**WITTER REMODEL**  
 DALLAS, TEXAS

EXTERIOR ELEVATIONS

**WITTER RESIDENCE**

**RES-POOL-25-000384 ( 9612 ROCKBROOK DR )**

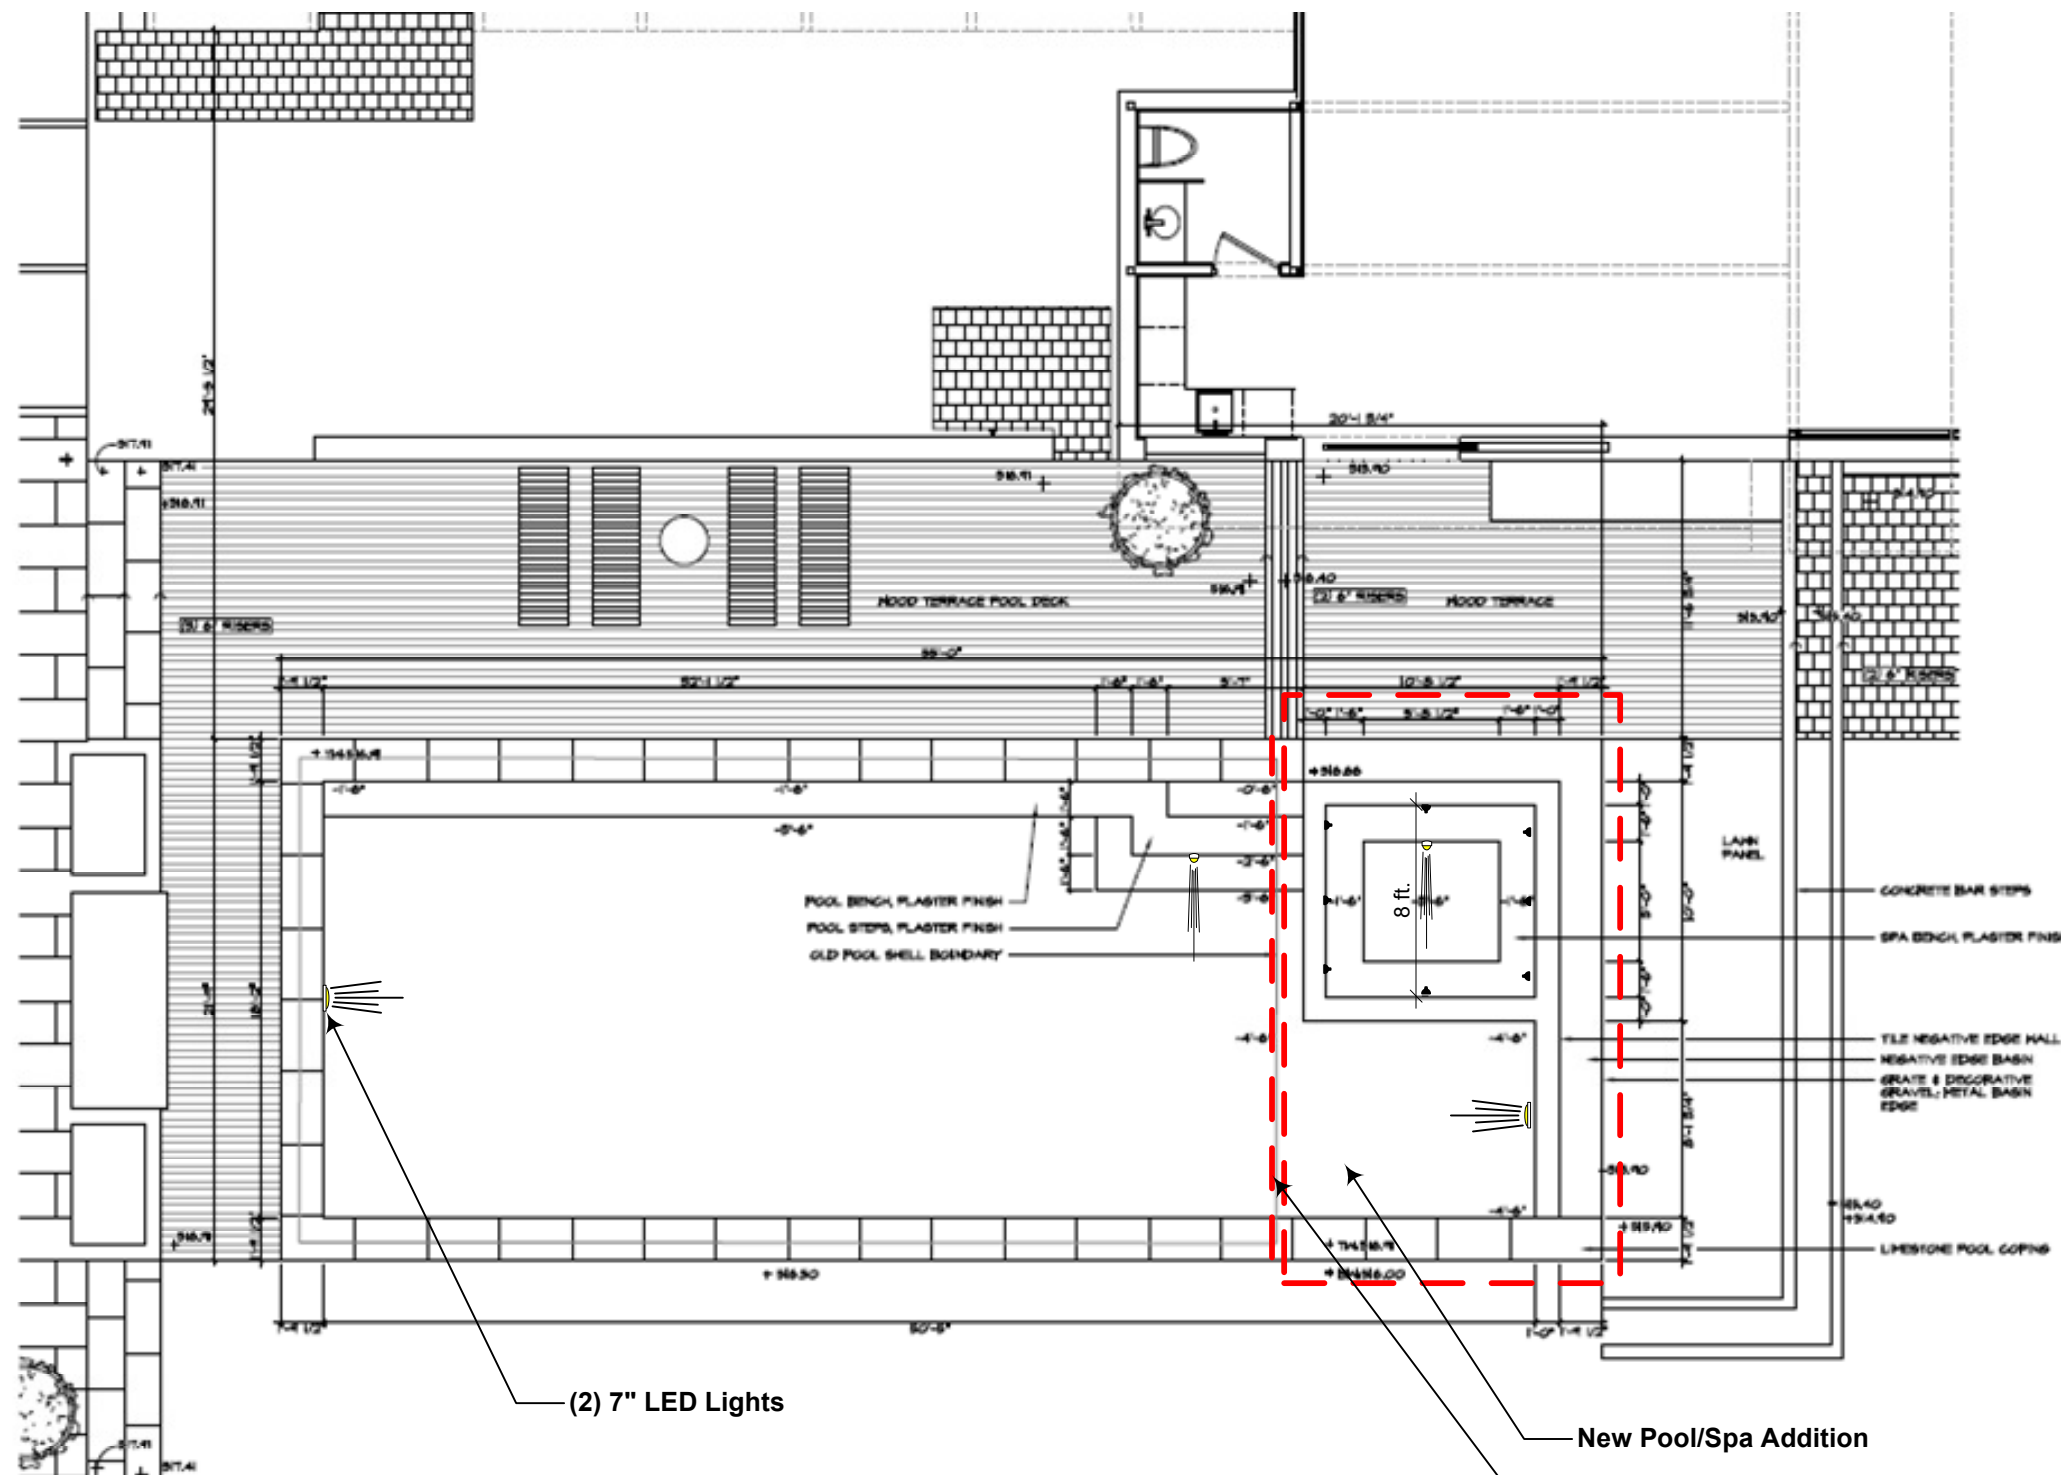
1- Please provide previous pool plans with dimensions because of the addition on of the pool. New Pool/spa addition. Will need to go to the Board of Adjustment for the new addition of the pool.
